SUBJECT: License Amendment Request; Changes to 10 CFR 50.63 Licensing Basis, Supplement 5
Vermont Yankee Nuclear Power Station
Docket No. 50-271
License No. DPR-28

Vermont Yankee Nuclear Power Station
Response to Request for Additional Information

Vermont Yankee Nuclear Power Station
Voltage and Frequency Response of Test Motor

Motor Starting on Generator Set Frequency & Voltage Response

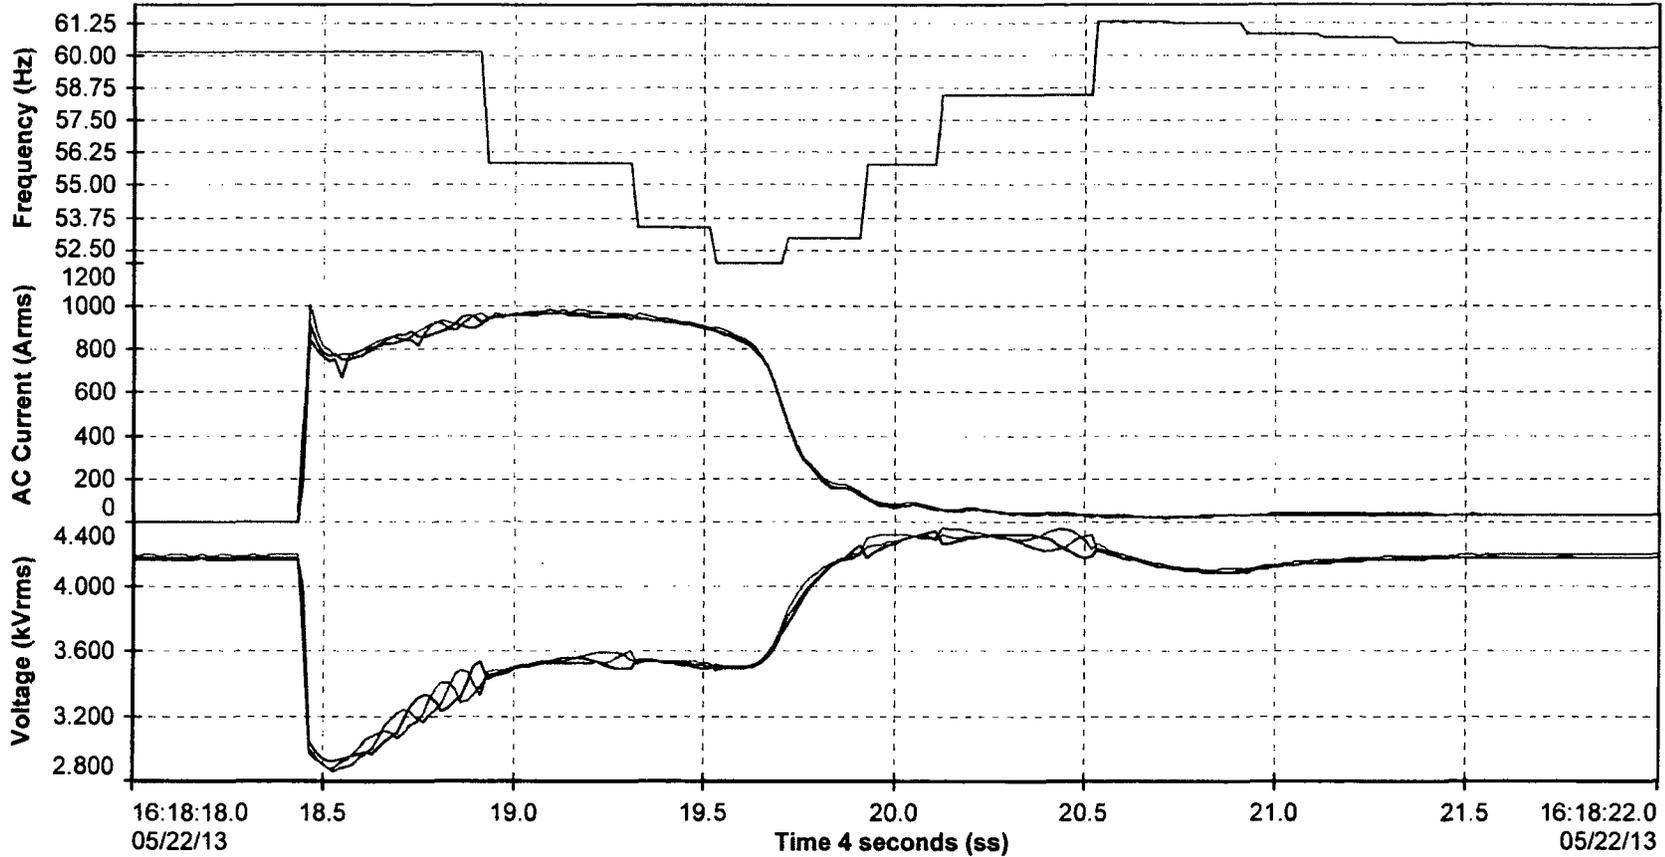
The 1250 HP test motor was started by the SBO DG. Attachment 2 is a trace of the test results. The trace depicts voltage, frequency and starting current. The test results indicate that voltage dipped to a minimum of 2860 volts, a 31.25% dip from nominal 4160 DG voltage. This represents a dip of 28.5% from nameplate motor voltage. This dip is less than the 36% voltage drop to 2662 V when starting a single RHR pump motor on an EDG and is therefore acceptable. Voltage started to recover within 0.1 seconds of the application of the load and recovered to above the RHR pump motor starting voltage of 3200 V within approximately 0.25 seconds from minimum voltage. (Note: The VY RHR pump motor can start its load with a sustained voltage of 3200 V (80 percent of nameplate voltage). The SBO DG voltage recovers well above minimum starting voltage, thus assuring rapid motor start.)

During the starting test, inrush current started to drop, voltage recovered to close to nominal and frequency started to recover approximately 1.5 seconds after load application. This indicated that the motor was nearly at full speed. The motor had fully accelerated when frequency reached 60 Hz, approximately 2.0 seconds after application of the load. Voltage and load current reached steady-state conditions approximately 3.0 seconds after application of the load.
